Burlington Development Review Board

BURLINGTON DEVELOPMENT REVIEW BOARD

Tuesday, July 7, 2020, 5:00 PM

To: Development Review Board
From: Mary O'Neil, AICP, Principal Planner
Date: July 7, 2020
RE: 225 Elmwood Avenue; ZP20-0858CA

HULA CAMPUS
OVERALL SITE PLAN

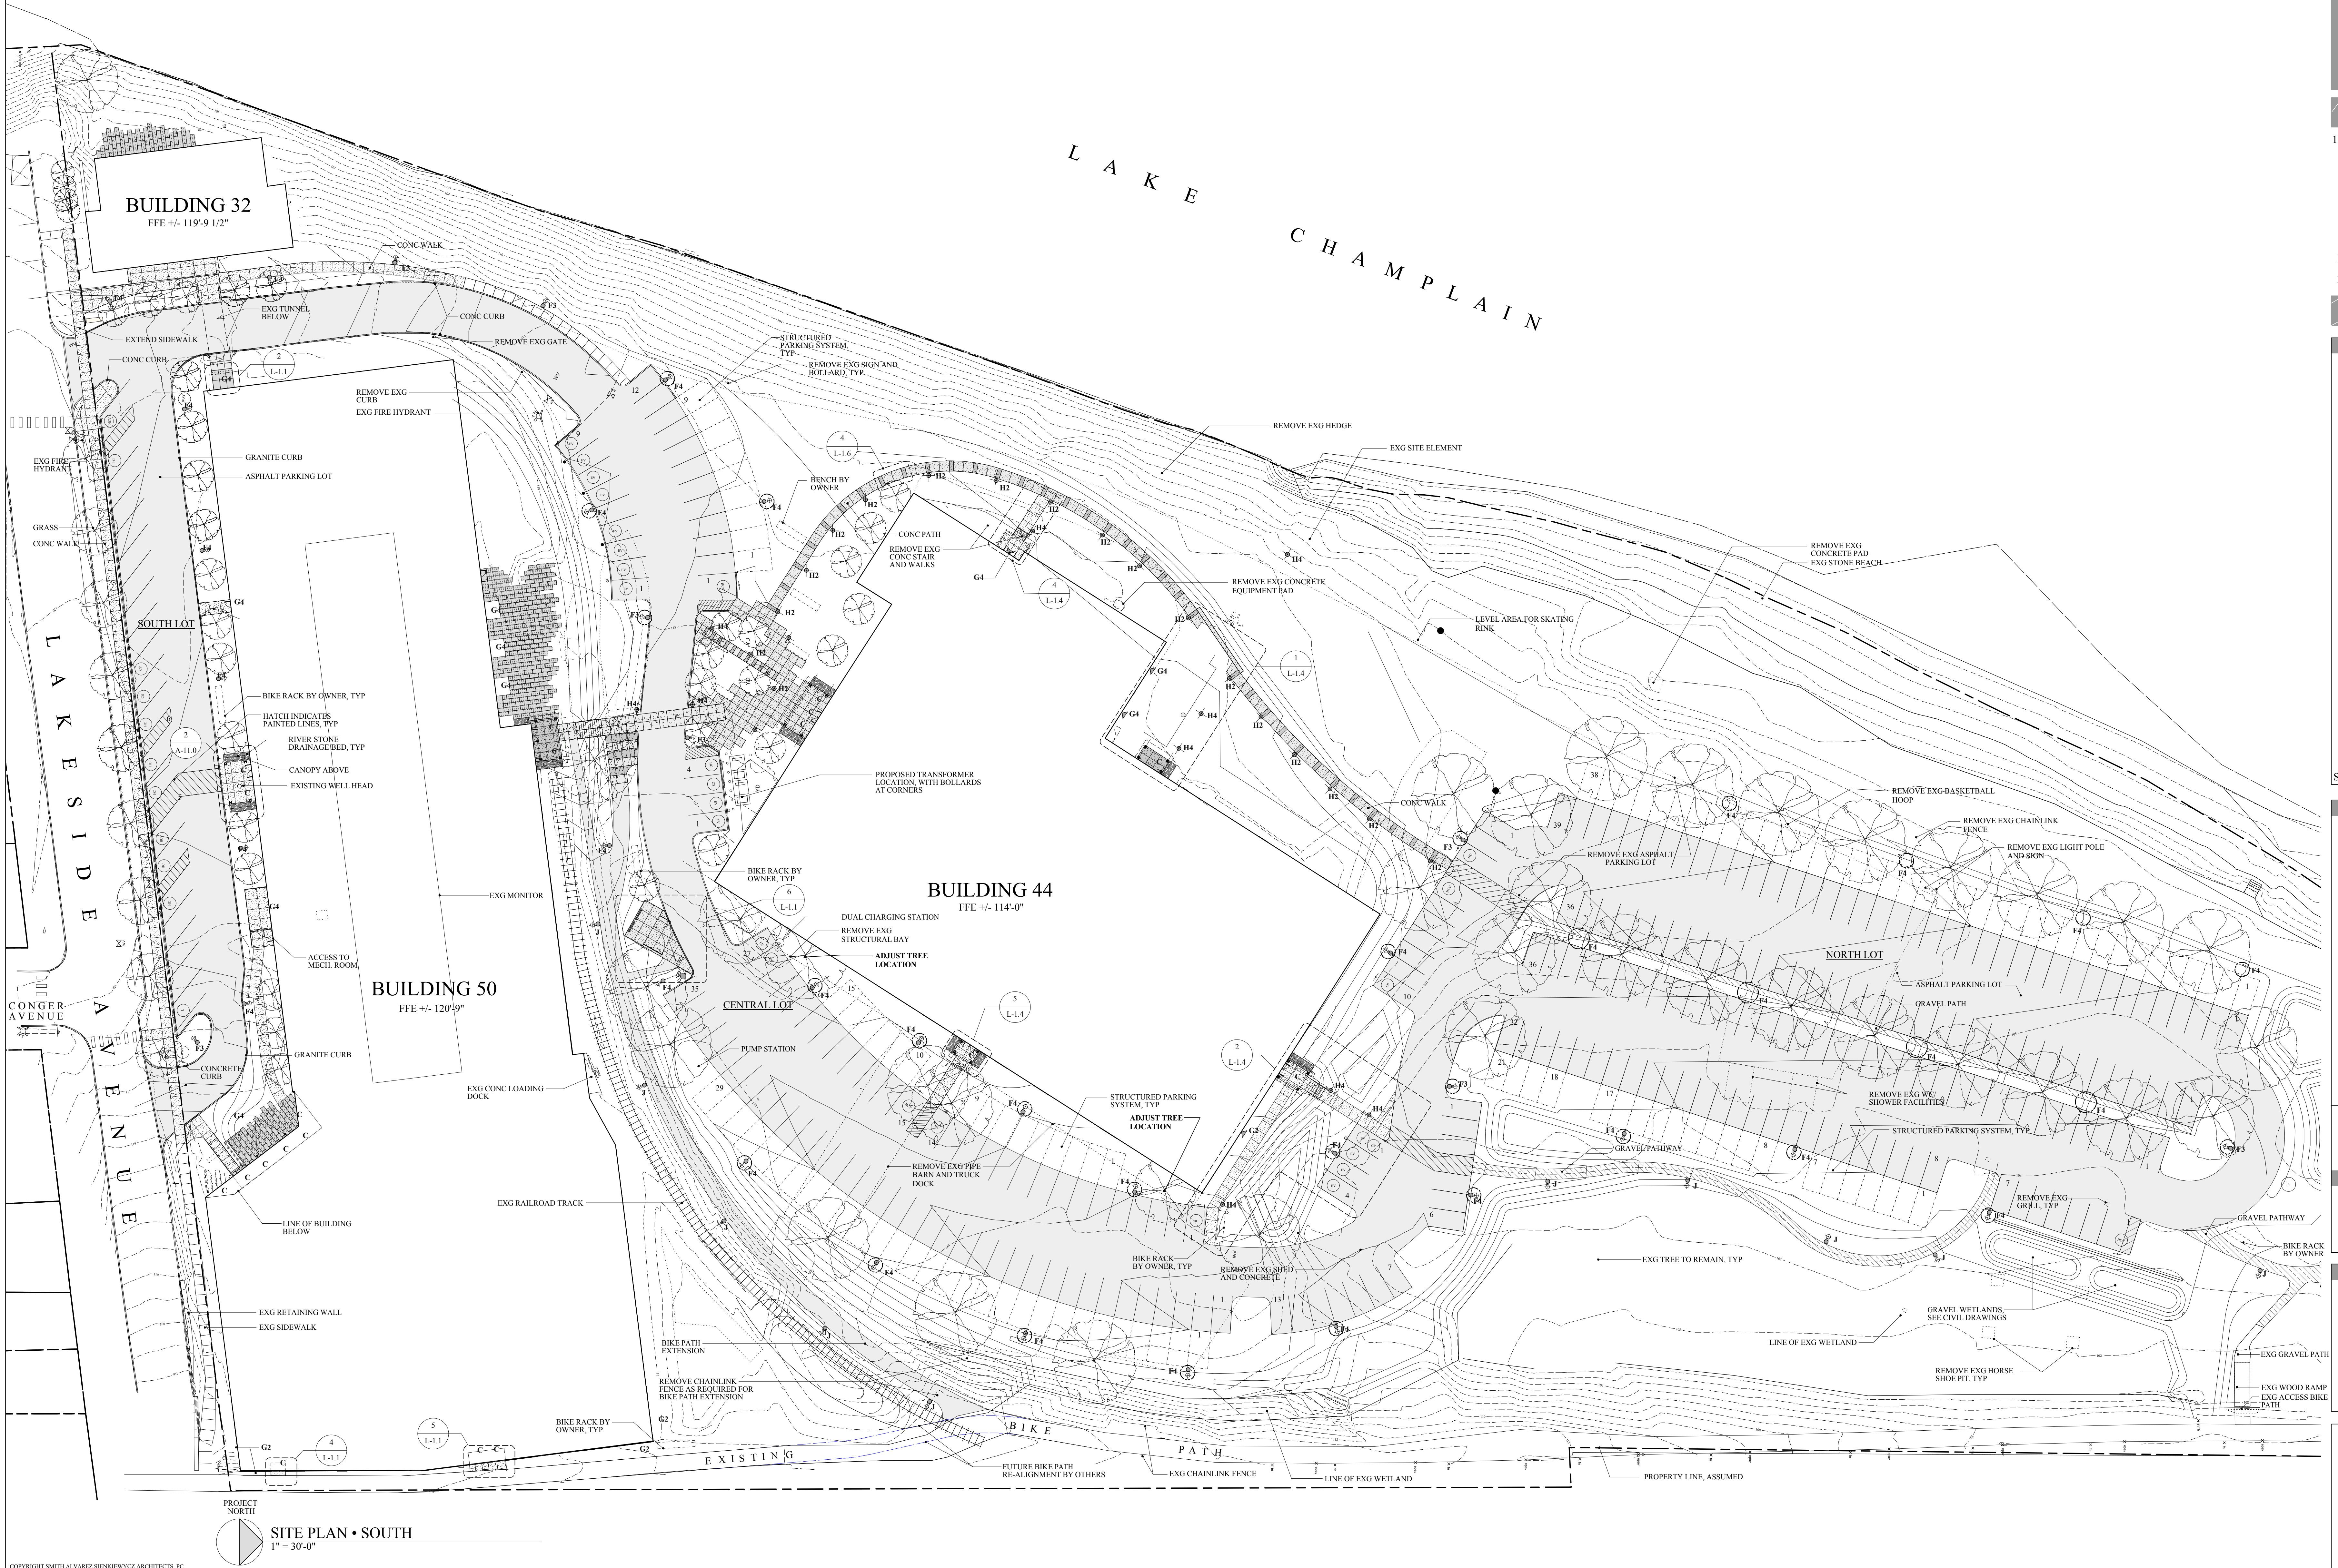
This application has minor modifications to the parking plan, appending the surface parking to 386 parking spaces (+5 over 19-0202 approval). See Plan L-1.1, with mark-up. The additional spaces include one conventional space (total 274) and 4 more tandem spaces (total 112.) **The surfeit on the overall lot is 77 spaces; easily accommodating the additional 11 parking spaces required of the new building.** (Proposed building 14,450 sf – existing building 9,200 sf = 5,250 sf @ 2/1000 in Shared Use district; 11 new parking spaces required.) Approval of the Parking Management Plan was within ZP19-0202CA/MA, including tenant managed parking assignment. A condition of approval will adopt conditions associated with that Parking Management Plan, to assure success of the plan and to prevent any on-street neighborhood parking with the expanded office building.

See Plan L-1.0 for a breakdown of parking requirements, Plan L-1.1 for identification of parking layout. **Affirmative finding as conditioned.**

The overall parking layout has been previously approved under ZP19-0202CA/MA. Five new spaces have been added; notably two accessible spaces immediately east of this building in the parking area south of Building 50. See Plan L-1.1 for identification of new spaces. Drive aisles and parking space sizes remain acceptable. **Affirmative finding.**
